HISTORIC AND DESIGN REVIEW COMMISSION

HDRC CASE NO: 2024-218
ADDRESS: 502 E DEWEY PLACE
LEGAL DESCRIPTION: NCB 1733 BLK 9 LOT 1 & W 5.6 FT OF 2
ZONING: MF-33
CITY COUNCIL DIST.: 1
DISTRICT: Tobin Hill Historic District
APPLICANT: Sinuhe Maldonado/Sol Studio Architects, LLC
OWNER: Leslie Cockerill/NEELY ALEXANDER & NEELY LESLIE
TYPE OF WORK: Fenestration modifications; new construction of accessory structures; driveway, parking pad, and rear walkway installation; landscaping
APPLICATION RECEIVED: June 05, 2024
60-DAY REVIEW: August 4, 2024
CASE MANAGER: Jessica Anderson

Re: Cockerill / Neely Patio Cover at 502 East Dewey Pl. San Antonio Texas –
Submittal Request for Certificate of Appropriateness

PROPOSED NEW CONSTRUCTION - COVER PATIO

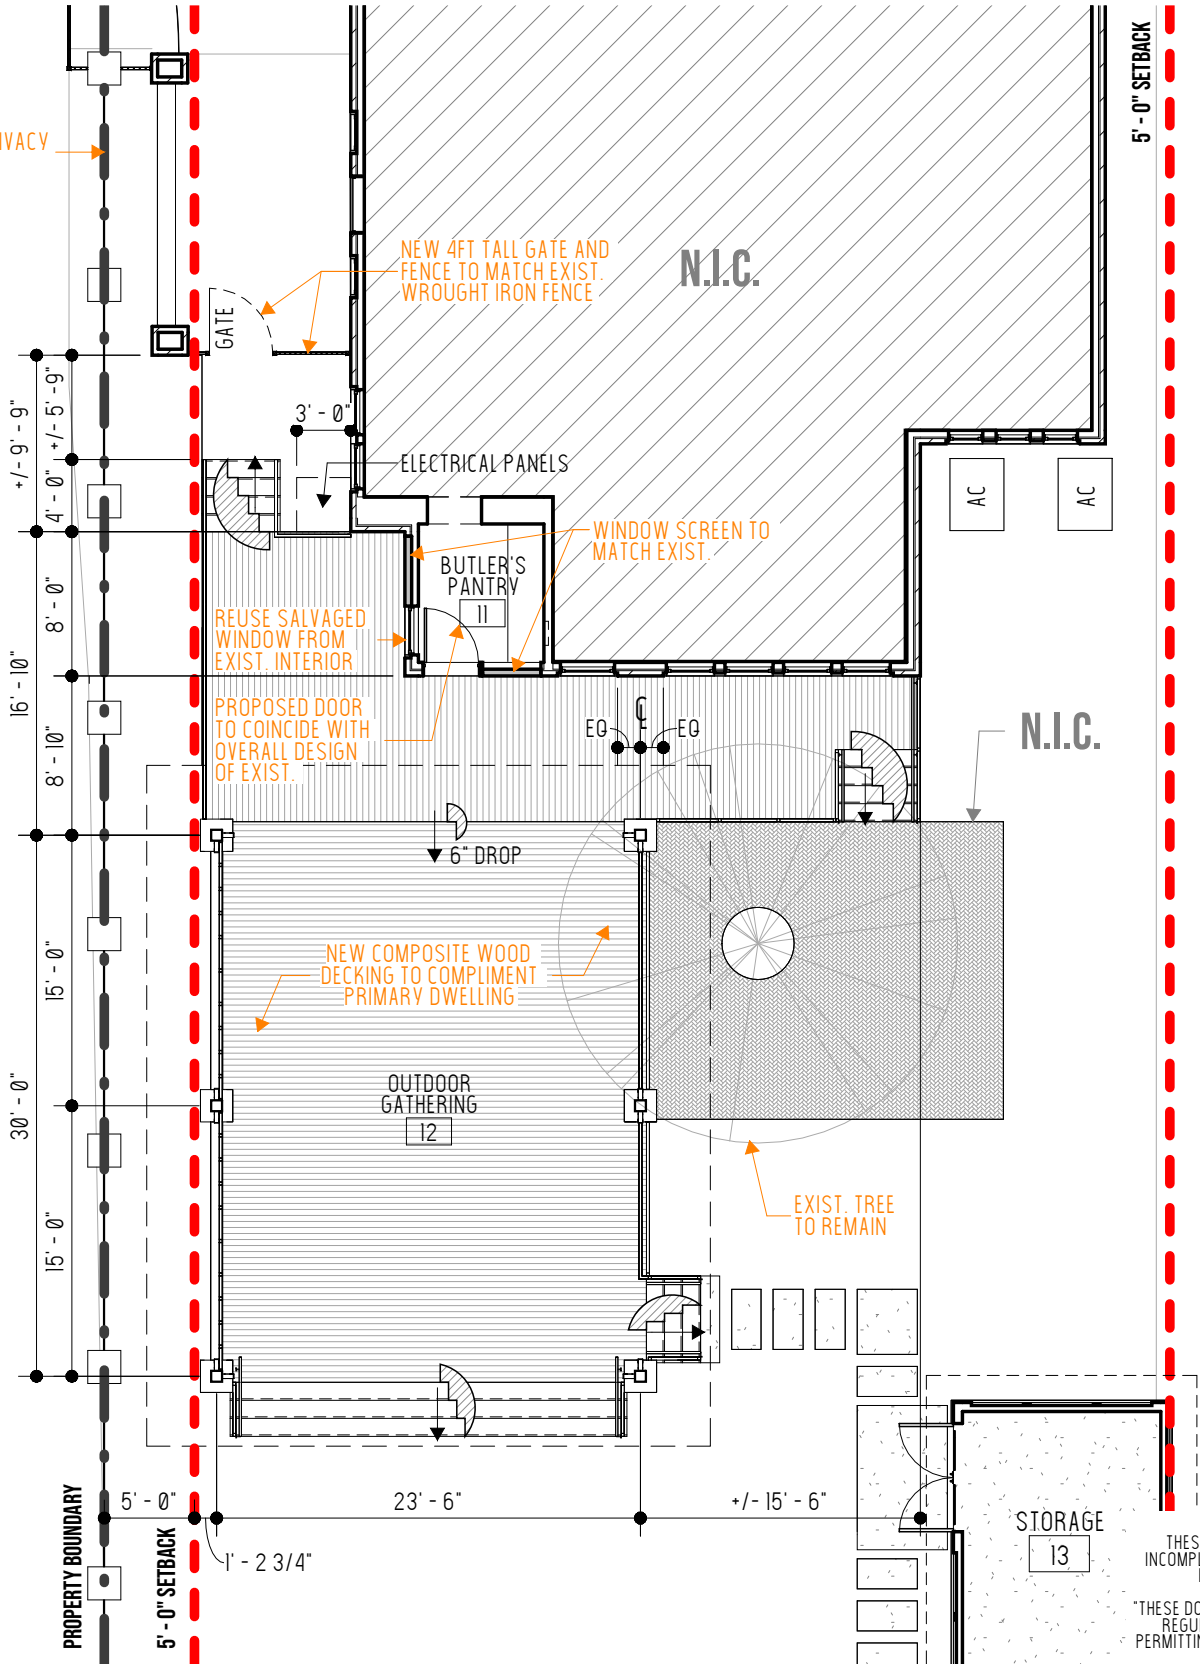
- c. **REAR DECK WITH COVER:** The applicant proposes to construct a rear deck with detached cover. The uncovered portion of the deck has a footprint of approx. 400 square feet, and the covered portion of the deck has a footprint of approx. 705 square feet. Historic Design Guidelines for New Construction 5.A. notes that new garages and outbuildings should be visually subordinate to the primary historic structure in terms of their height, massing, and form, and should be no larger in plan than forty percent of the primary historic structure's footprint. The existing one-story primary structure on the lot features a footprint of approx. 2,187 square feet, including the porte cochere and front porch. The proposed deck with detached cover features a total footprint of approx. 1,105 square feet, or approximately 50% of the primary structure's footprint. Staff finds the rear deck with cover generally appropriate, and that the size of the lot allows for the additional coverage proposed.

- d. **REAR DECK WITH COVER (ARCHITECTURAL DETAILS AND MATERIALS):** The applicant proposes a composition deck with brick piers and wood posts supporting a wood-frame roof. The hipped roof is clad in red standing seam metal to match the primary structure. The posts feature a decorative brace to match the porte cochere on the primary structure. A stucco-clad wall with a screen is proposed for the west side of the cover. Historic Design Guidelines for New Construction 3.A.i says to use materials that complement the type, color, and texture of materials traditionally found in the district. Materials should not be so dissimilar as to distract from the historic interpretation of the district. Staff finds the proposed materials conform to guidelines, but that the applicant must submit detailed information about the screen materials and submit a detailed drawing of the proposed railings.

- i. That the applicant submits detailed information about the screen materials and submit a detailed drawing of the proposed railings, as noted in finding d.
- ii. That the applicant installs a standing seam metal roof featuring panels that are 18 to 21 inches wide, seams that are 1 to 2 inches high, a crimped ridge seam, and match the current finish or a standard galvalume finish. Panels should be smooth without striation or corrugation. Ridges are to feature a double-munch or crimped ridge

PROPOSED NEW CONSTRUCTION - STORAGE

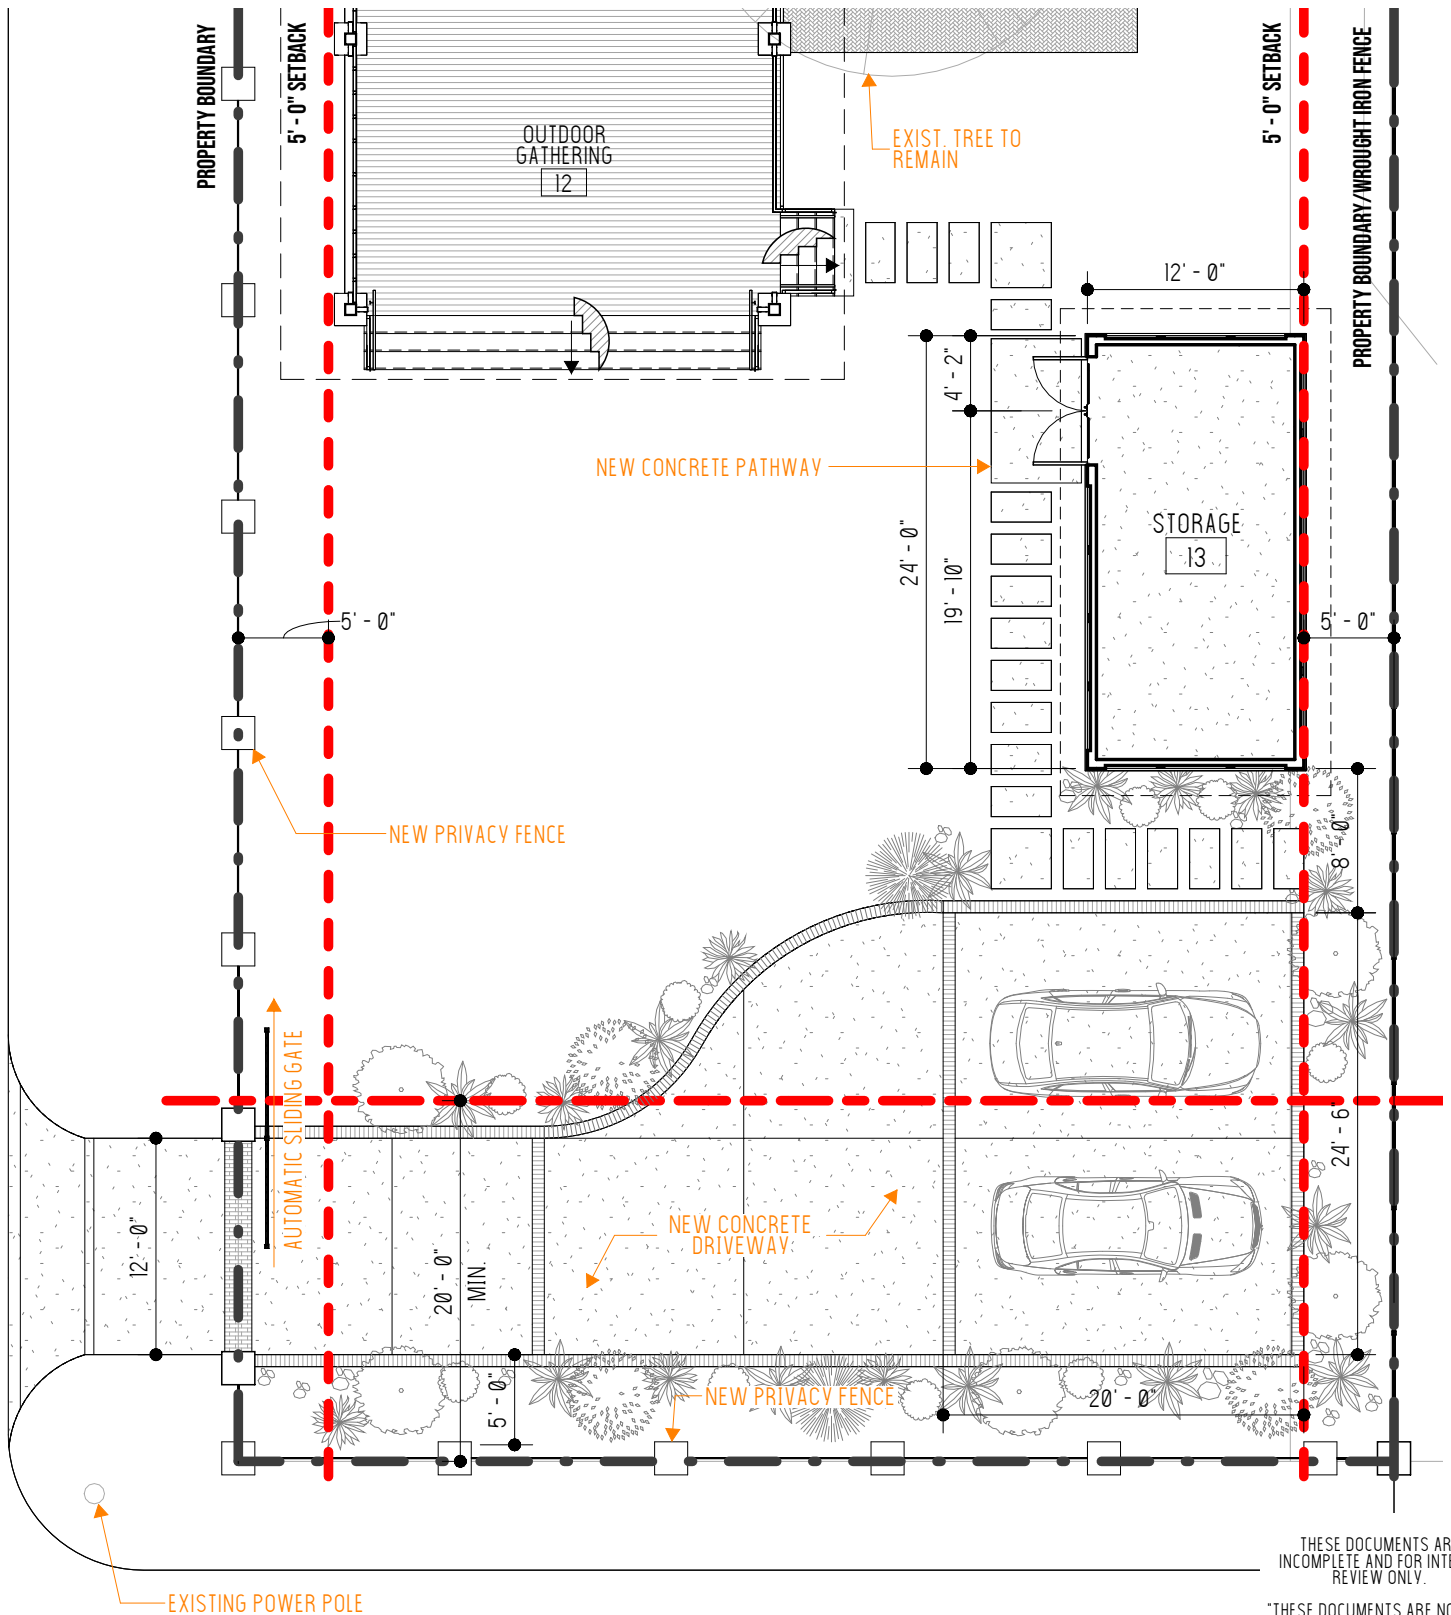
- f. **NEW CONSTRUCTION OF AN ACCESSORY STRUCTURE:** The applicant proposes to construct a rear detached accessory structure with a footprint of 288 square feet. Historic Design Guidelines for New

Construction 5.A. notes that new garages and outbuildings should be visually subordinate to the primary historic structure in terms of their height, massing, and form, and should be no larger in plan than forty percent of the primary historic structure's footprint. The existing one-story primary structure on the lot features a footprint of approx. 2,187 square feet, including the porte cochere and front porch. The proposed detached accessory structure has a footprint of 288 square feet, or approximately 13% of the primary structure's footprint. Staff finds the rear detached accessory structure conforms to guidelines.

- g. **NEW CONSTRUCTION OF AN ACCESSORY STRUCTURE (ARCHITECTURAL DETAILS AND MATERIALS):** The applicant proposes a rear detached accessory structure with a hipped roof clad in red standing seam metal to match the primary structure and clad in stucco, teardrop siding, and Hardie trim. A pair of French doors with a divided transom are included on the west elevation. Historic Design Guidelines for New Construction 2.C.i says to incorporate window and door openings with a similar proportion of wall to window space as typical with nearby historic facades. Staff finds the proposed accessory structure generally appropriate. The applicant must also submit materials information for the proposed doors and transom, typically in the form of manufacturer's specifications.

- i. That the applicant submits materials information for the proposed doors and transom, typically in the form of manufacturer's specifications, as noted in finding g.
- ii. That the applicant installs a standing seam metal roof featuring panels that are 18 to 21 inches wide, seams that are 1 to 2 inches high, a crimped ridge seam, and match the current finish or a standard galvalume finish. Panels should be smooth without striation or corrugation. Ridges are to feature a double-munch or crimped ridge configuration; no vented ridge caps or end caps are allowed. An inspection must be scheduled with OHP staff prior to the start of work to verify that the roofing material matches the approved specifications.
